FIELD CHANGE ORDER	NUMBER: KN220-0001
--------------------	--------------------

APPLICABILITY: All DECsystem 5500's with Revision D or E M7637-AA CPU modules.

PROBLEM & SYMPTOM: Power-up self test writes in one location in NVRAM (Pres-
toserve). If these self tests are run as a result of a power failure, this
location will be corrupted BEFORE the NVRAM data is written back to the disk.
There is no indication that data has been corrupted.

FIGURE 1

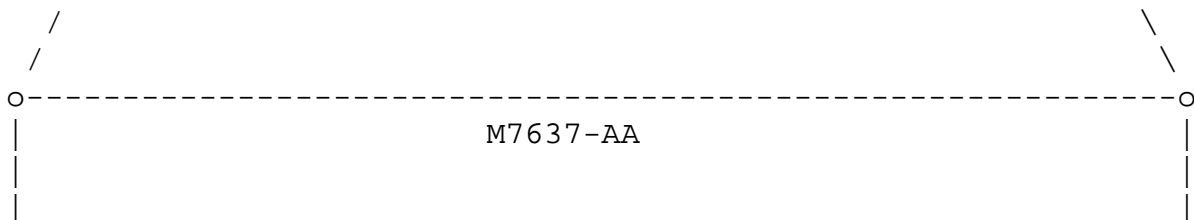
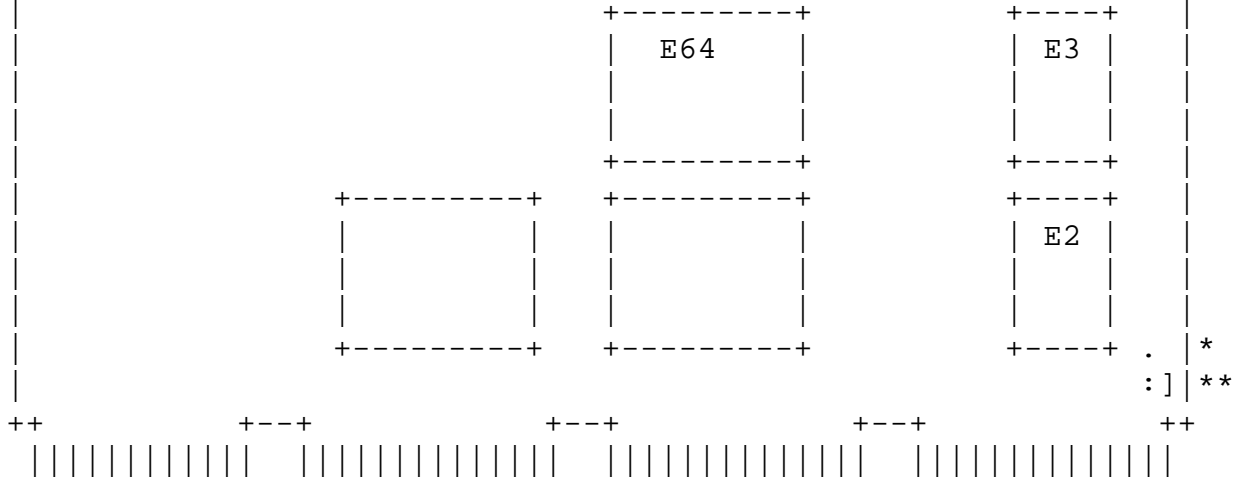
- a. Remove the new module from the kit. Disable the Prestoserve battery backup on the old module (see above), fill out a repair tag (See Attachment B), attach the tag to the module and return it to the packaging of the new module.
- b. Enable the Prestoserve battery backup on the new module. (See Figure 1 on Page 4.)
- c. Install new module and test.
- d. The M7637 label on the bulkhead must be modified to reflect the new F04 revision. Also, the same is true for any applicable site guides.
- e. After completion of testing, the system is ready for operation in accordance with procedures applicable to the customer/site procedures.
- d. Follow example (Attachment A) when recording your labor activity.

*Prestoserve battery backup disabled **Prestoserve battery backup enabled
